Amendment No. 1

Generation Interconnection Agreement

**Maverick Creek Wind, LLC
(Maverick Creek Wind II)**

FIRST AMENDMENT TO THE ERCOT STANDARD GENERATION INTERCONNECTION AGREEMENT

Exhibit "C1" **Point of Interconnection Details**

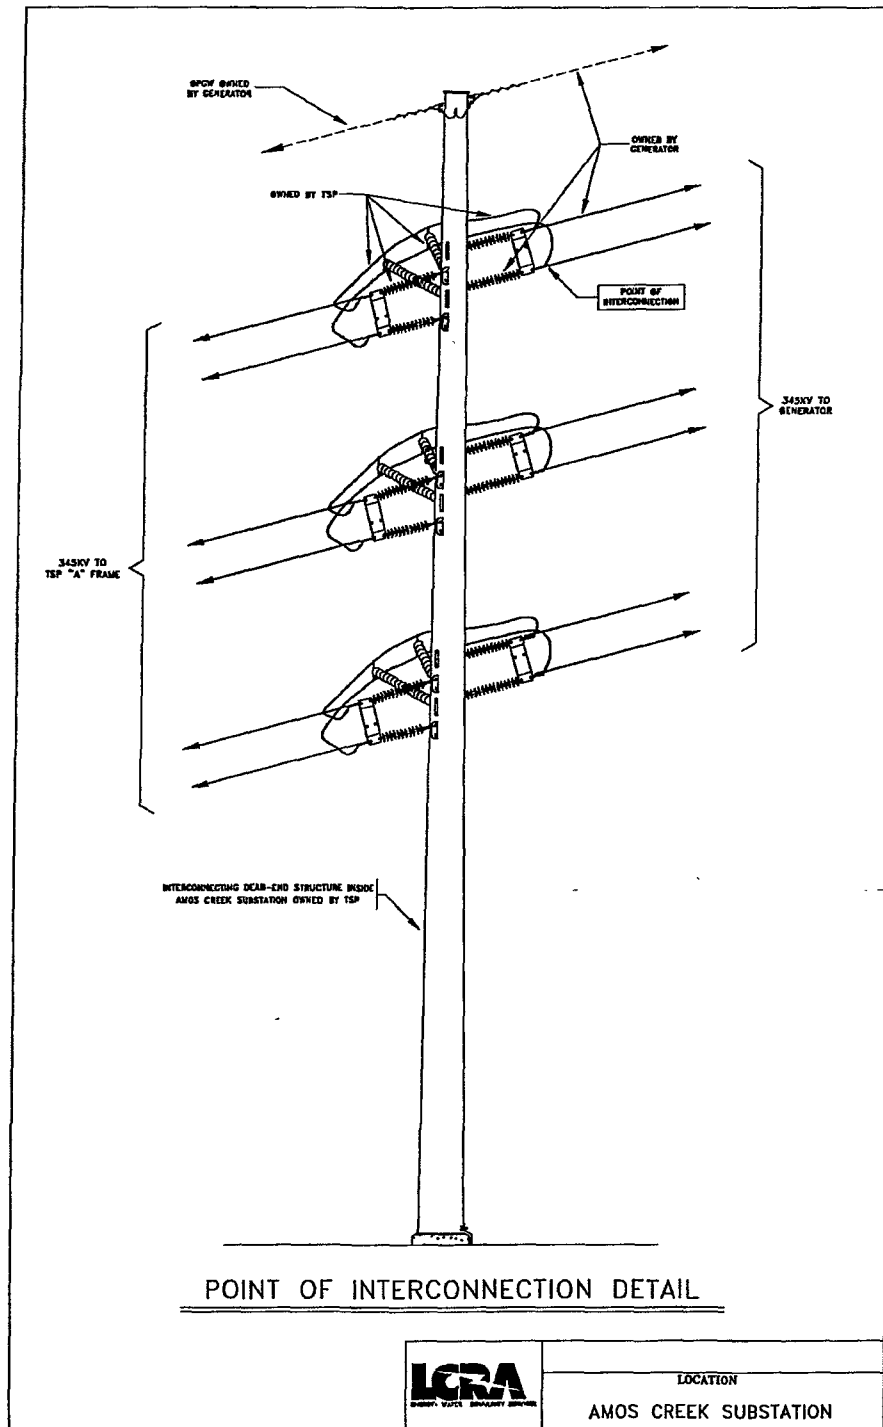
1. Name: Maverick Creek Wind II
2. Point of Interconnection location: The Point of Interconnection will be at the new LCRA TSC Amos Creek Substation ("TSP Substation") located in Concho County, TX along the existing LCRA TSC 345-kV transmission line T424, at the approximate location shown in Exhibit "C3". The Point of Interconnection, shown on Exhibit "C1" and Exhibit "C2" shall be the physical point where the LCRA TSC Amos Creek Substation facilities are connected to the GIF. This point is more specifically defined as being located at the 4-hole pad terminals on the dead-end assembly where the Co-Tenant Generator's 345-kV line connects to LCRA TSC's interconnect structure.

One Line Diagram – TSP Interconnection Facilities, Generation Interconnection Facilities and the Plant

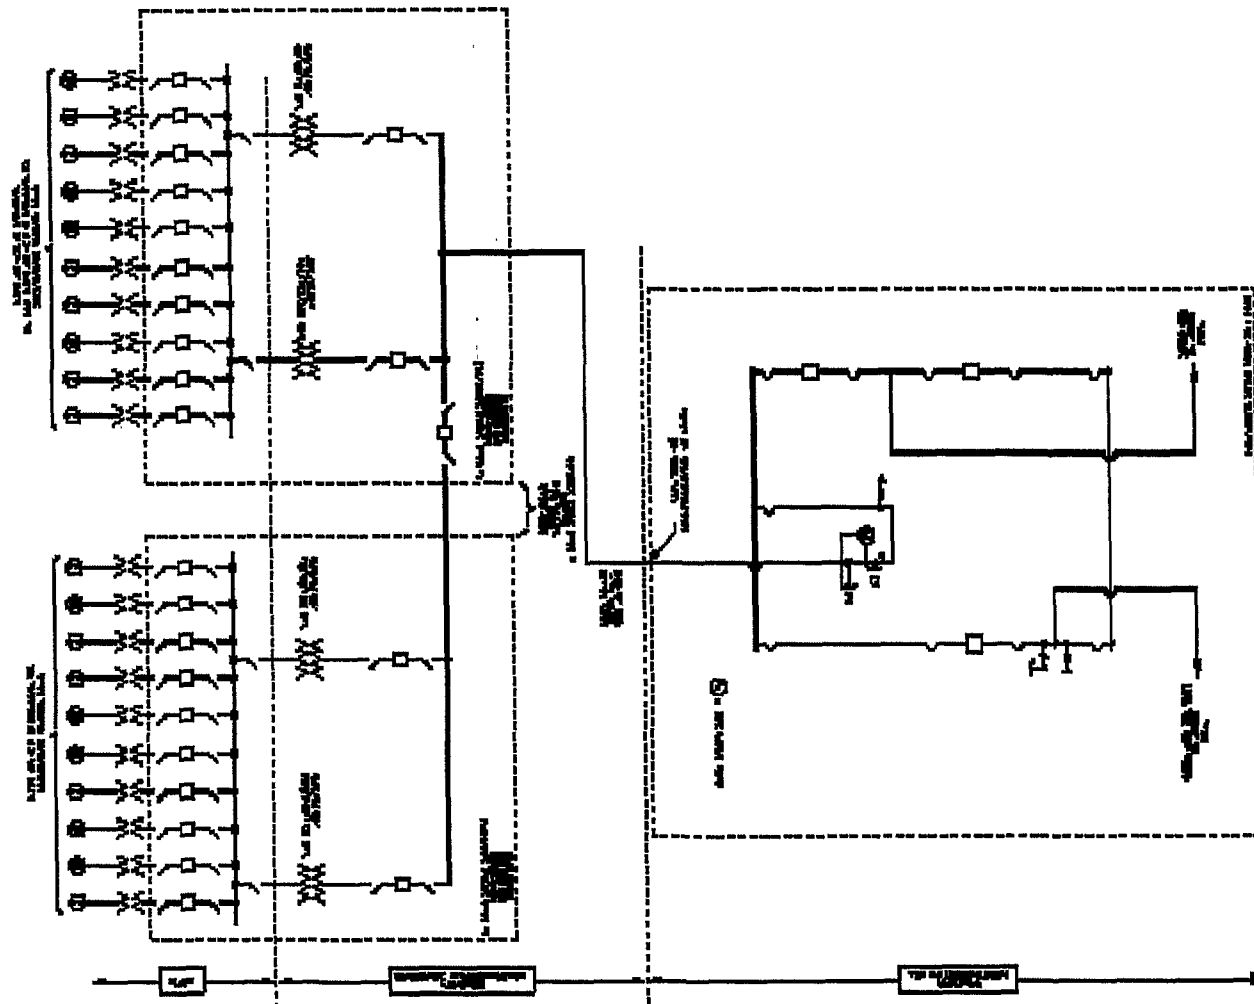
3. Delivery Voltage: 345-kV
4. Number and size of Generating Units ("The Plant"): The Plant is a wind generation facility with one Point of Interconnection to the grid through a Co-Tenant Generator Line. The Plant rating will be approximately 151.2-MWs of AC power at the Point of Interconnection.

5. Type of Generating Unit: Maverick Creek Wind II is composed of 36 Vestas V150 4.2MW Turbines.
6. Metering and Telemetry Equipment:
 - A). TSP's ERCOT polled settlement ("EPS") metering will be located at the TSP Substation as part of the TIF. 345-kV extended range, metering current transformers will be used to accurately read the generation energy and power delivered to the grid and the auxiliary energy and power consumed through the Point of Interconnection. Three 345-kV metering accuracy voltage transformers will also be installed by the TSP for the ERCOT settlement metering. The ERCOT settlement metering panel furnished by the TSP will be located in the TSP Substation.
